This meeting of the Grimes Planning and Zoning Commission was called to order Tuesday May 5, 2020 at 5:30 P.M. and was held electronically due to the global health pandemic.

TO: Planning and Zoning Commission
FROM: Evann Martin, Assistant Planner
DATE: July 7, 2020
RE: Golden Rule Plat 1- Preliminary Plat

TO: Planning and Zoning Commission
FROM: Evann Martin, Assistant Planner
DATE: July 7, 2020
RE: Sweet Honey – Site Plan

RE: Sweet Honey Site Plan - 2900 SE Destination Drive

INITIAL SWPPP (EROSION CONTROL)

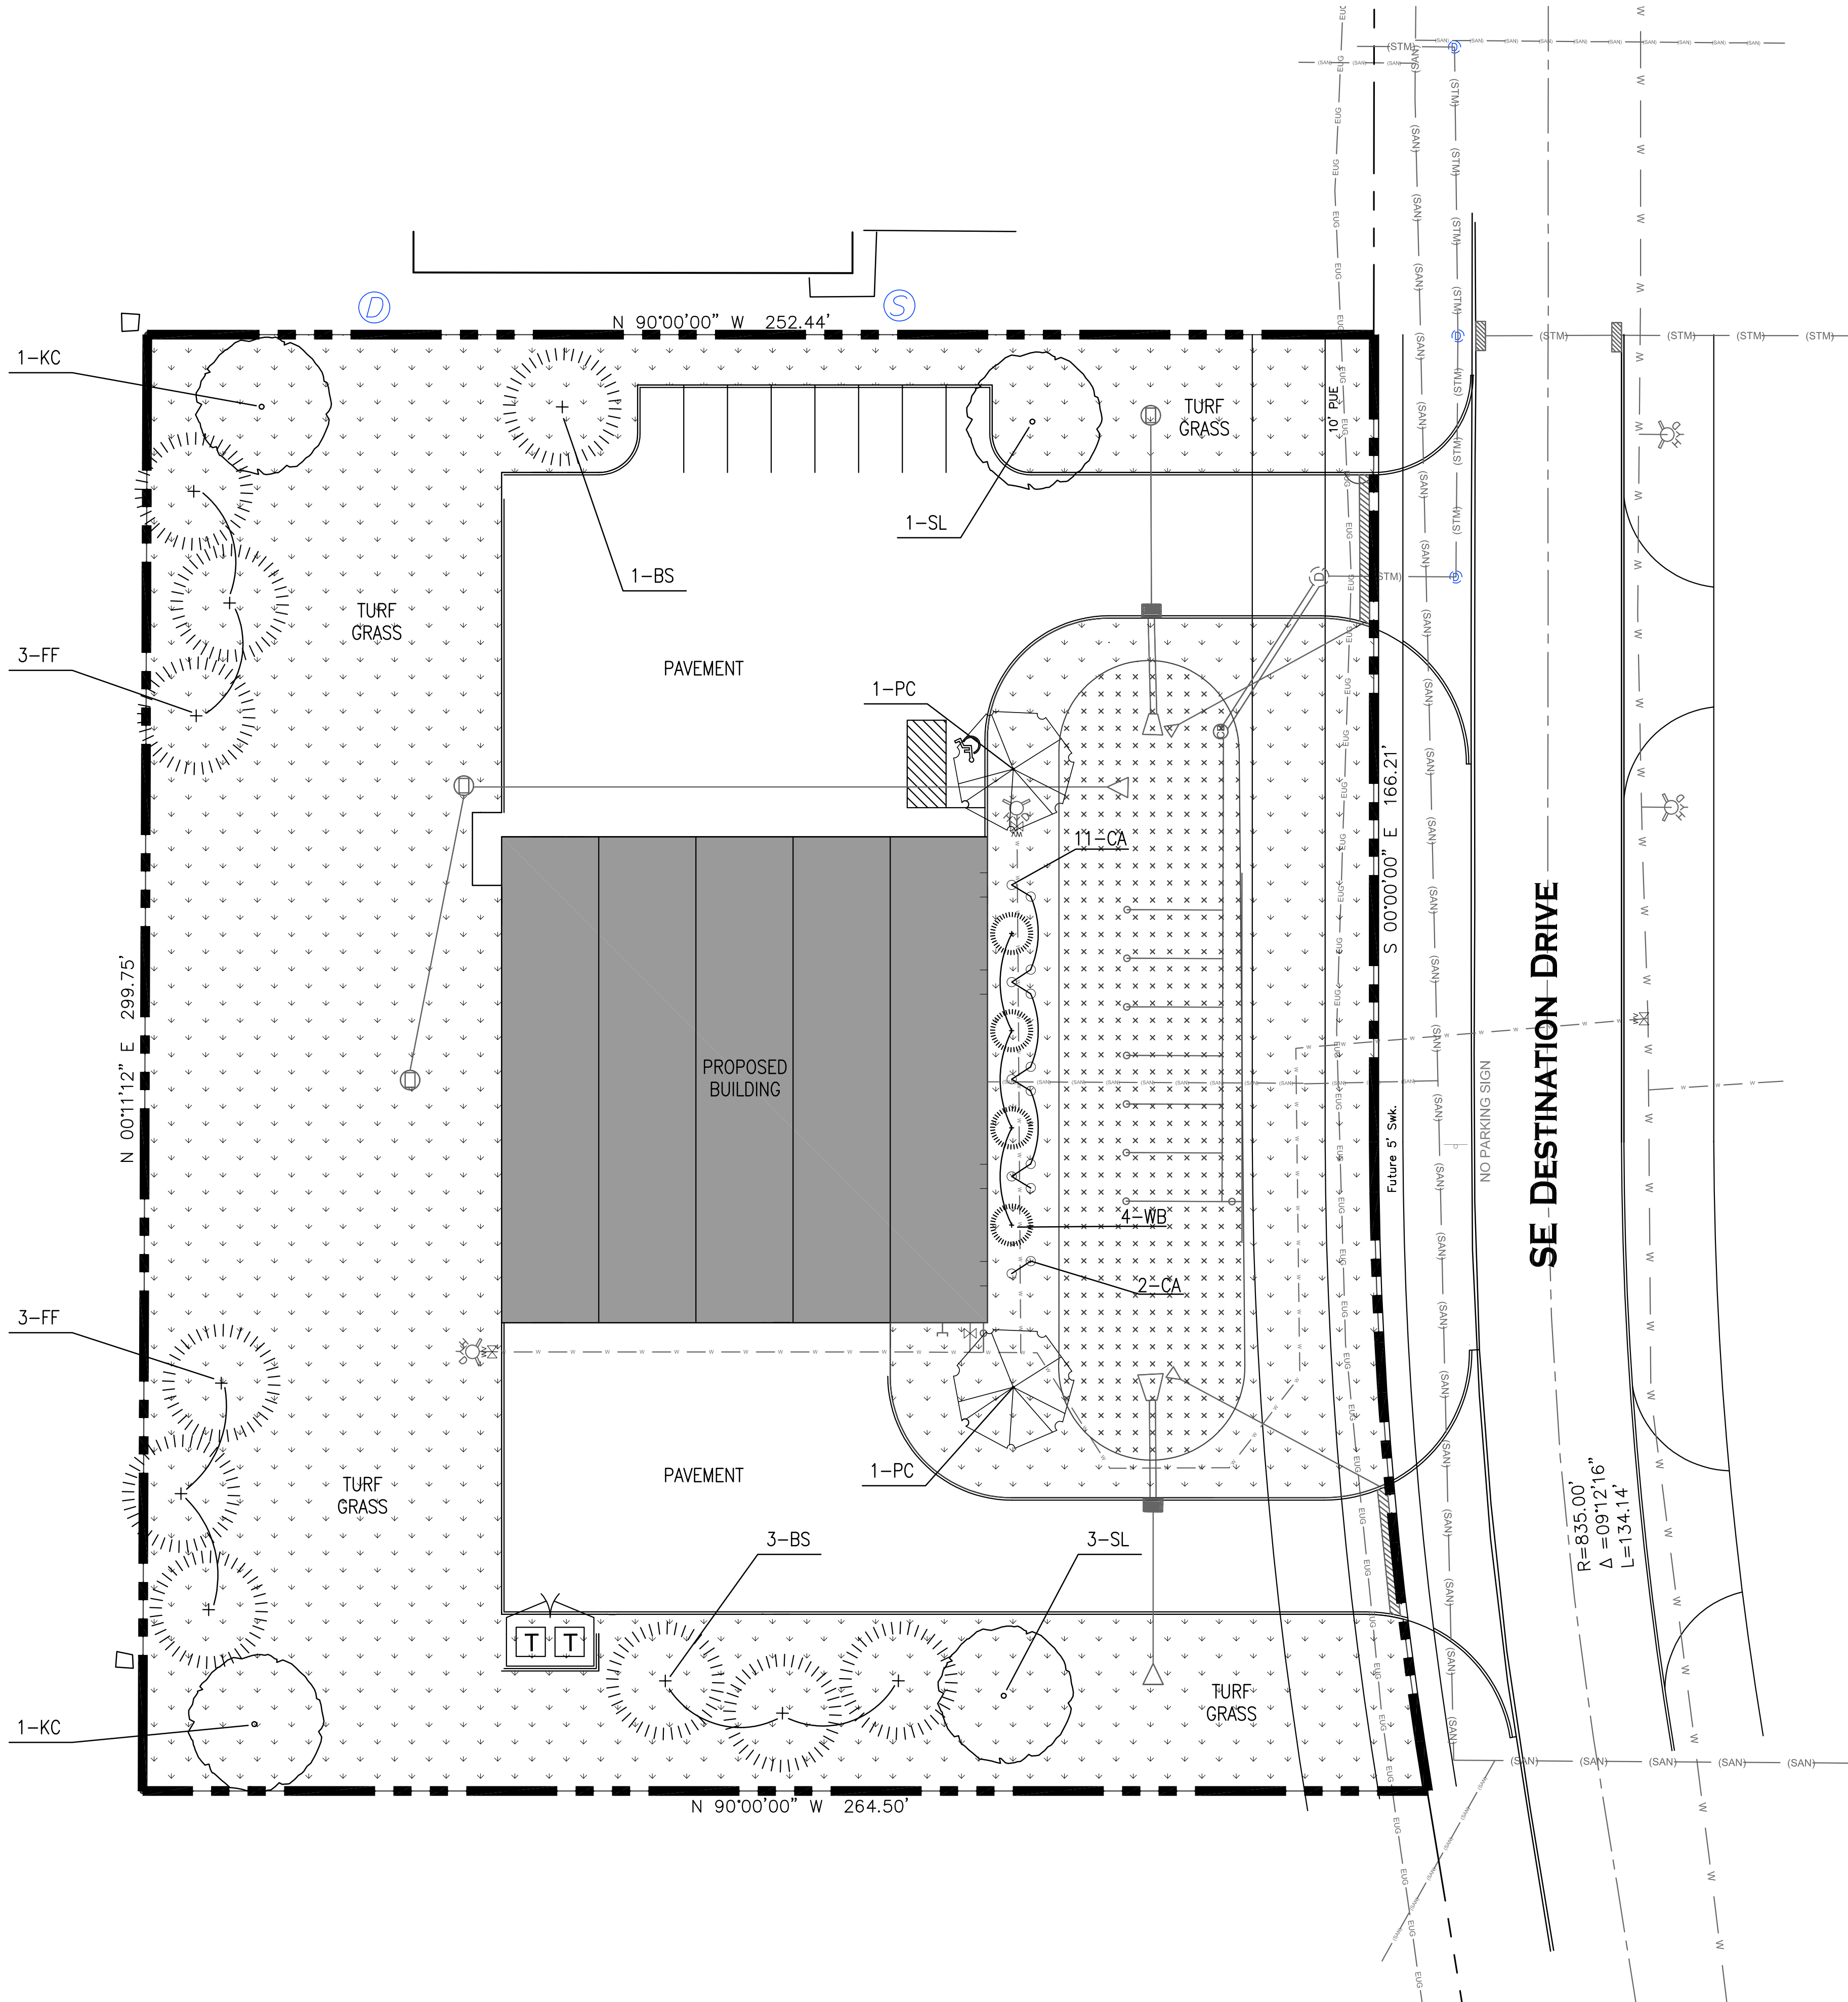
- ~~1. Submit a complete SWPPP for review in accordance with NPDES GP#2, Part IV, D.~~
- ~~2. Site Plan Sheet 9:~~
 - ~~a. Place inlet protection around all intakes — two are missing.~~
 - ~~b. Place inlet protection around outlet structure.~~
 - ~~c. Include quantities of silt fence, scour stop, inlet protection, temporary and permanent mulching and seeding, wattles, and filter socks.~~
 - ~~d. Include location of portable toilet at least 50 ft. from the nearest intake.~~
 - ~~e. Label the site discharge point.~~
- ~~3. Site Plan Sheet 9: list quantity of scour stop.~~
4. SWPPP Site Description: Correct project name.

5. SWPPP Page 69 and Site Plan Page 9 should match. Please rectify.

1 NORTH ELEVATION
SCALE: 1/8" = 1'-0"

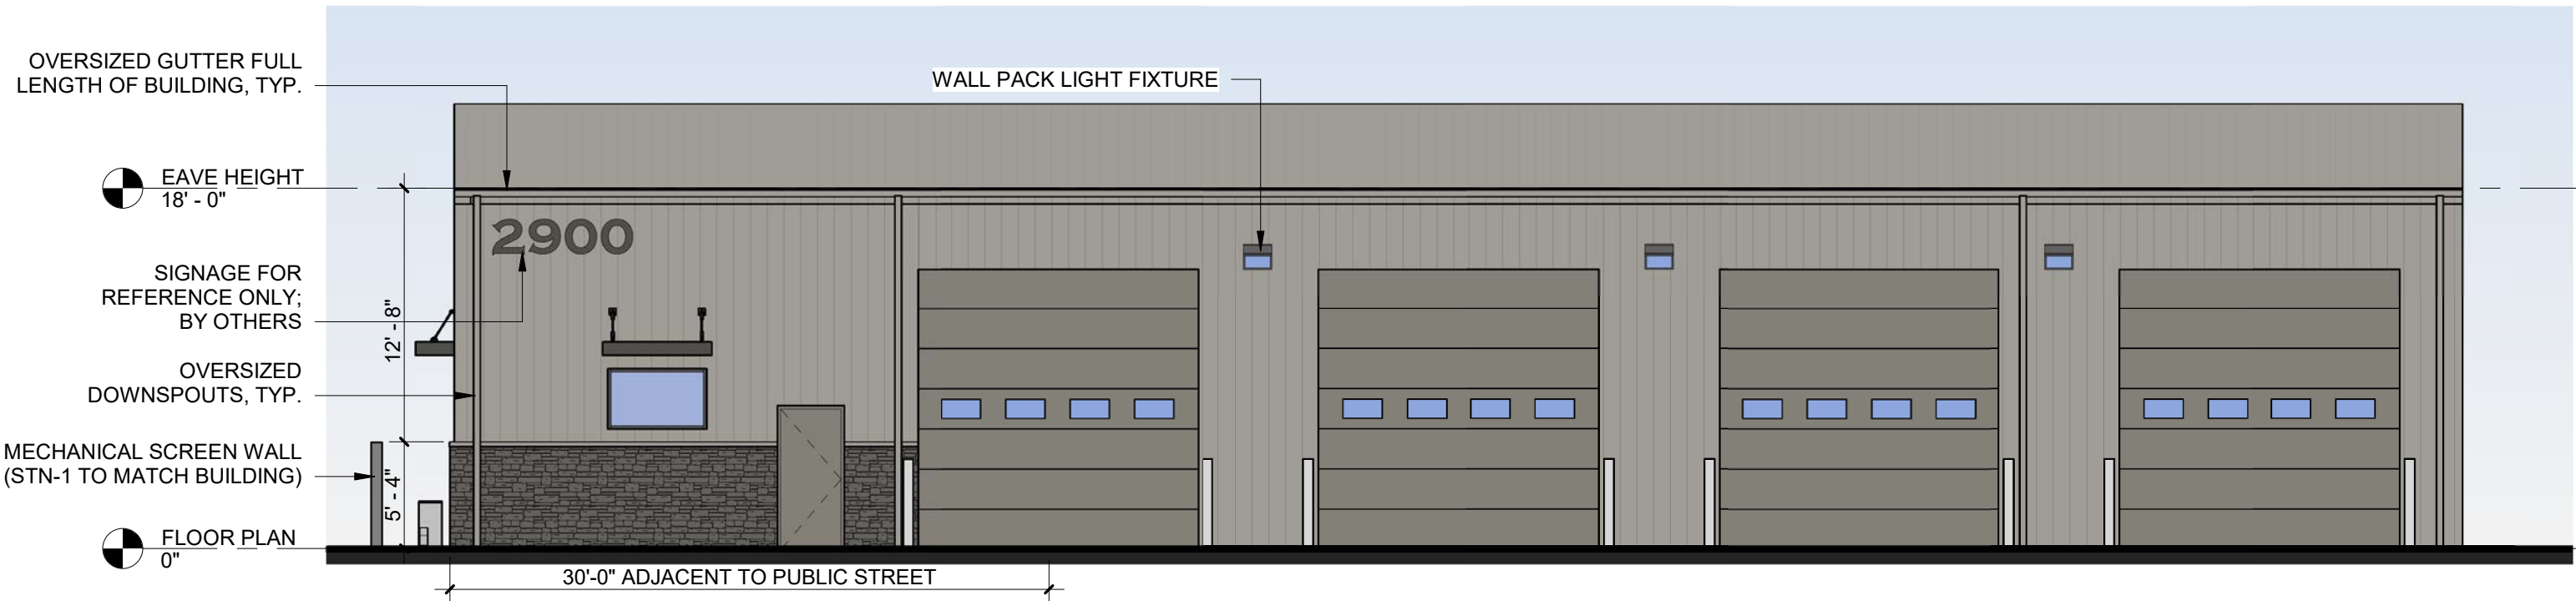
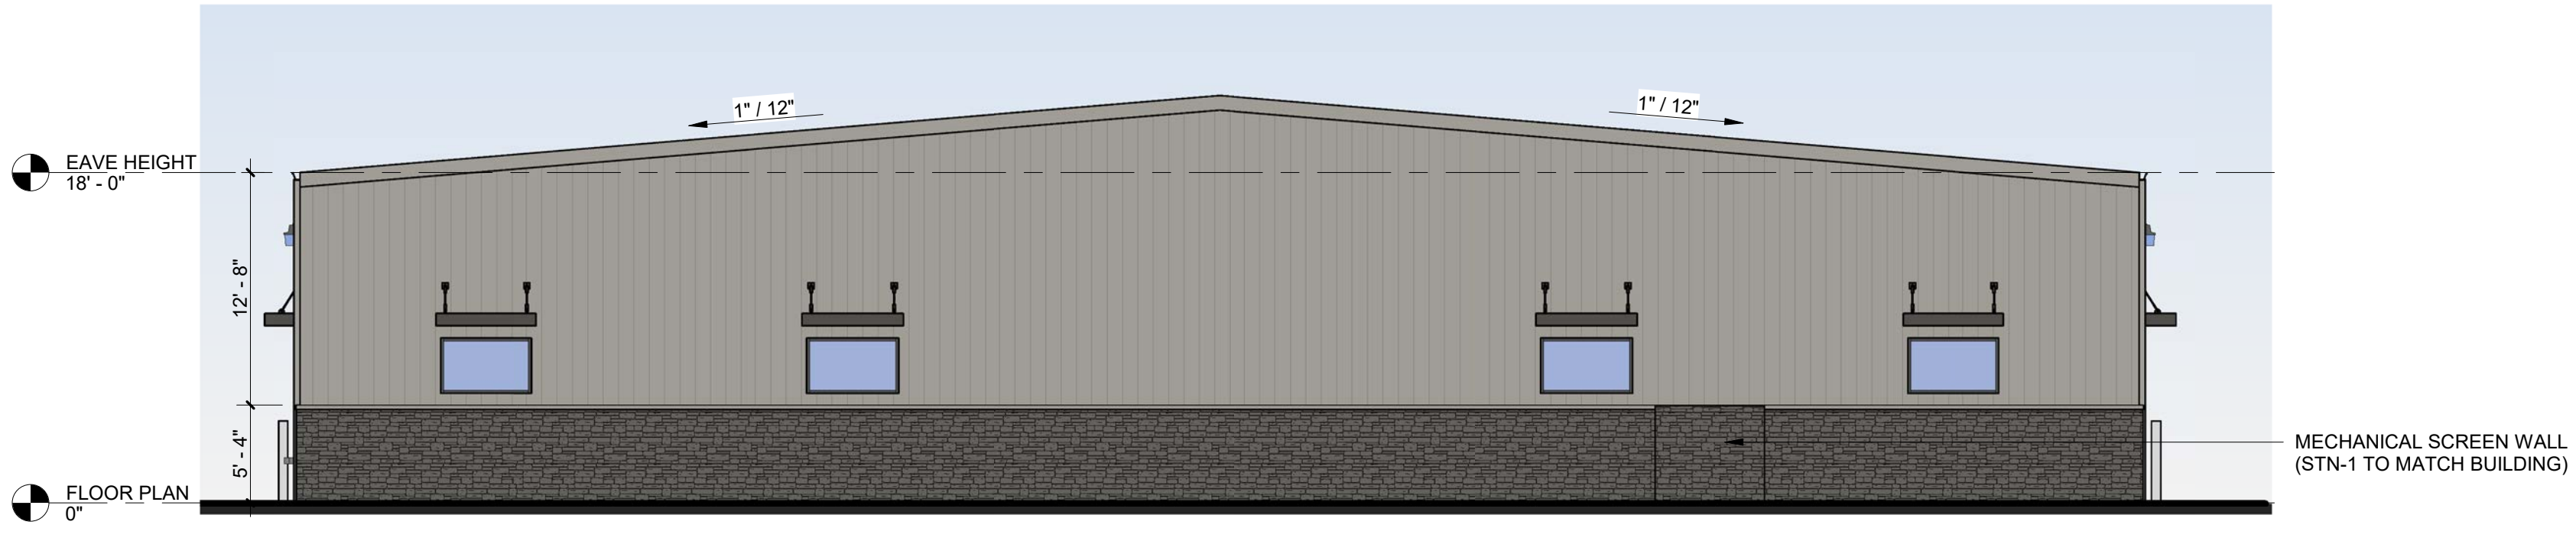
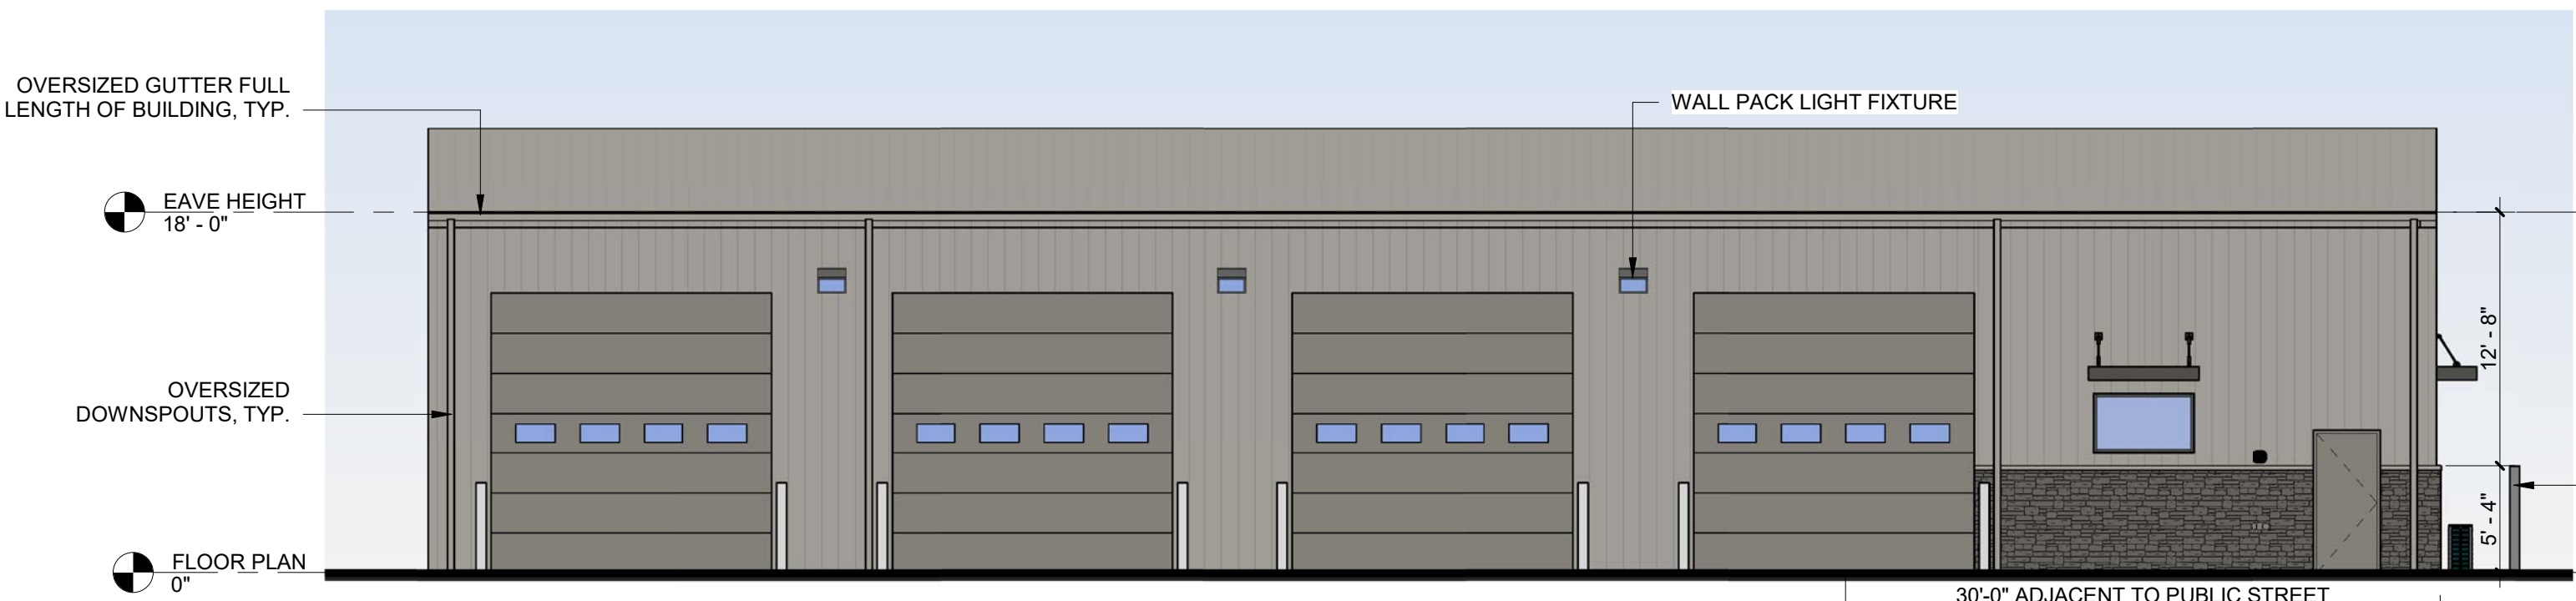
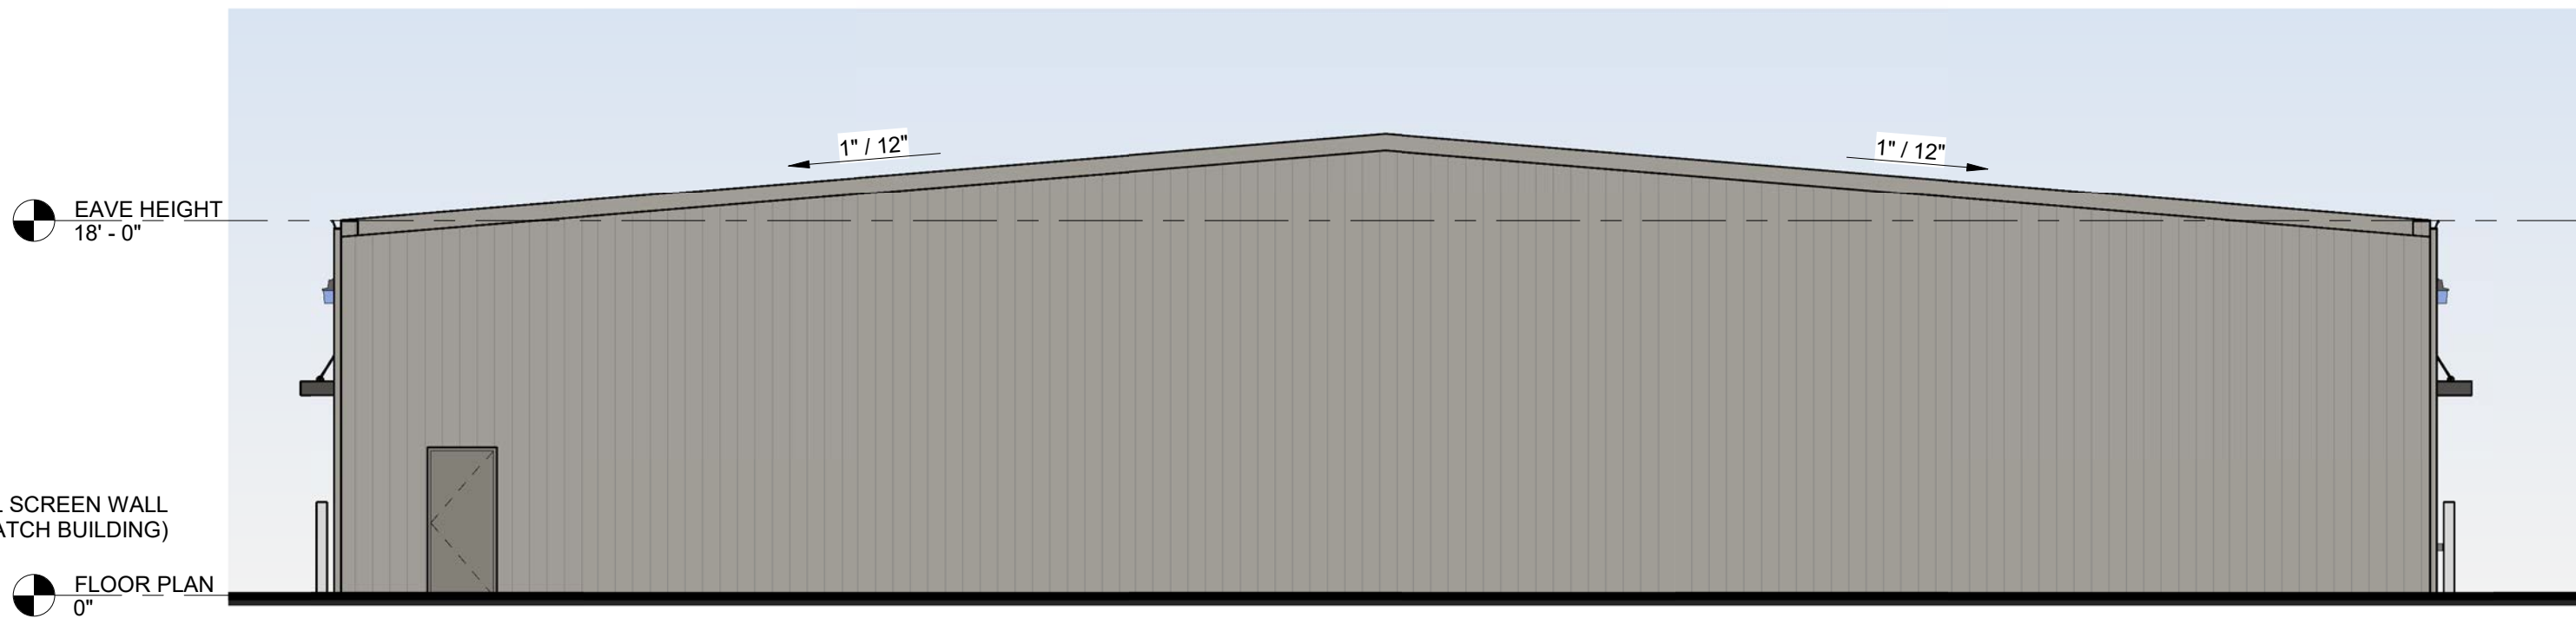
- ~~4. Commercial buildings shall incorporate façade modulation in all building elevations, either by physical offsets or by the use of color, pattern, or texture in order to preserve building scale and reduce the negative aesthetic impact of long, large, expansive wall surfaces. Please add additional features to the east elevation. Staff would like to see two additional windows on the front elevation.~~

- ~~5. Any roof-mounted mechanical, communications, or other similar equipment shall be screened from public view with similar design features to the building, including material, shape, and color. Show screening details on elevations.~~

- ~~6. Add wall pack lighting to the elevations.~~
